This software updates or alters the functions and features noted below. The instructions and information that follow are meant as a supplement to the original instruction manual that accompanied the T32MZ transmitter. Please refer to the original instruction manual where applicable, but replace the steps indicated below with these instructions. Please note that the software update will be finalized the first time that the T32MZ is powered up, after the software has been applied. As such, it may require a few moments before the Start screen appears. Please check to ensure that the update has been installed.

**T32MZ SOFTWARE UPDATE CHANGES****(Editor Version: 3.4 Encoder version: 1.2)**

## 1.Expansion of governor R.P.M. range

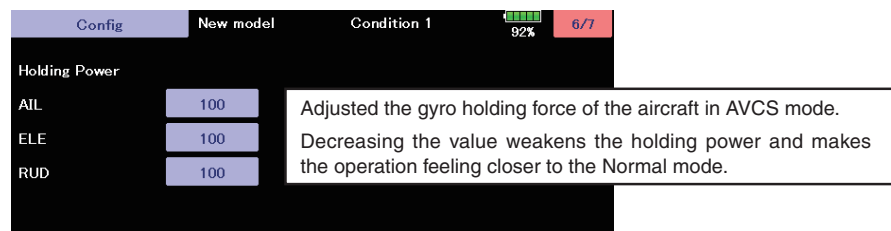
With the governor function of the model menu, the R.P.M. range has been expanded to 700 to 3500 rpm.

## 4.Add R.P.M. display : Gov Basic

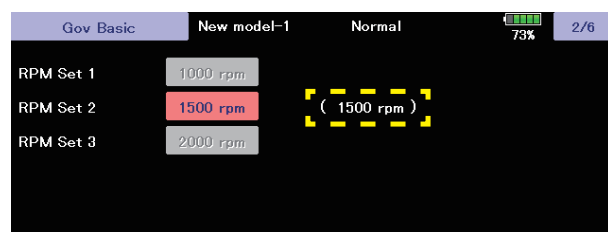
The number of revolutions of the governor setting is displayed on the governor basic screen of the gyro setting.

**2. Compatible with SCORPION ESC telemetry**

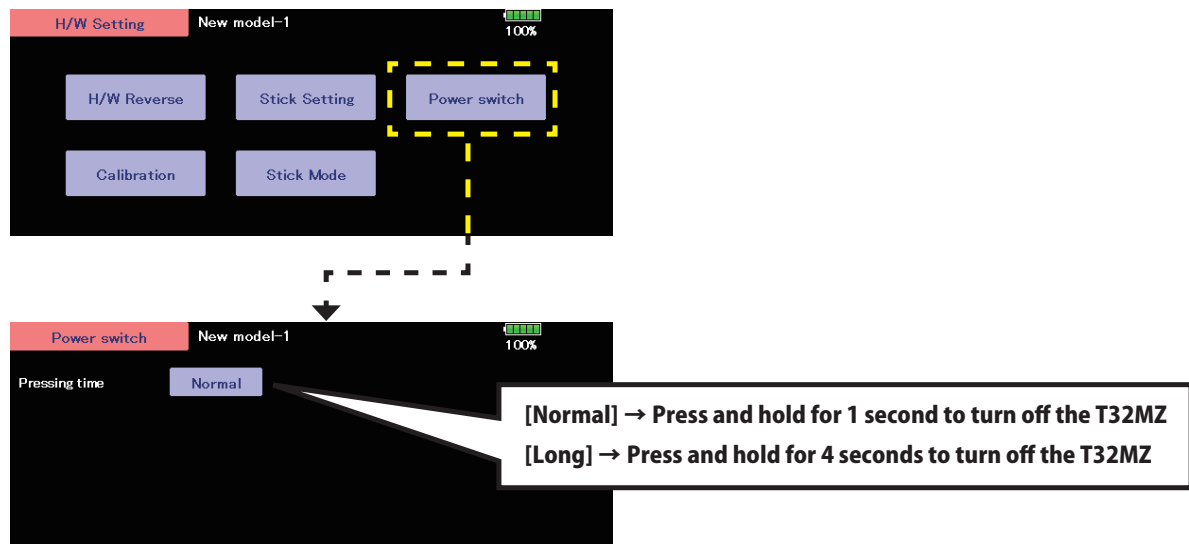
Added support for SCORPION POWER SYSTEM ESC some models.

## 1. Add Screen off function [Quick start]

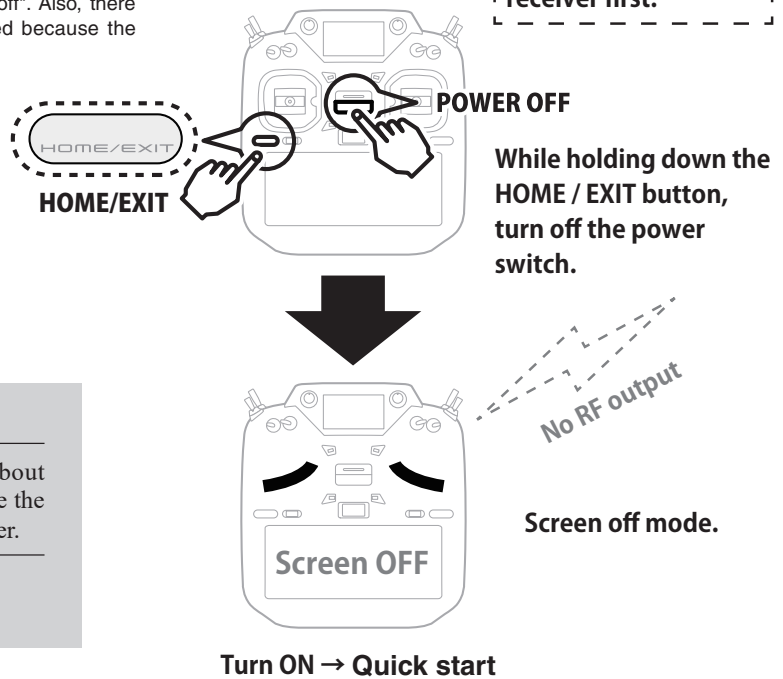
This "screen off" can quick start next startup. This is convenient when turning on and off frequently. No RF output at "screen off". Also, there is no screen display. However, the battery is consumed because the internal circuit is activated.

Be sure to turn off the receiver first.

- ⚠ While in screen off mode, it consumes about 4% of the battery per hour. If you do not use the transmitter for a long time, turn off the power.
- ⚠ Updates cannot be performed in screen off mode. To update, turn off the power.
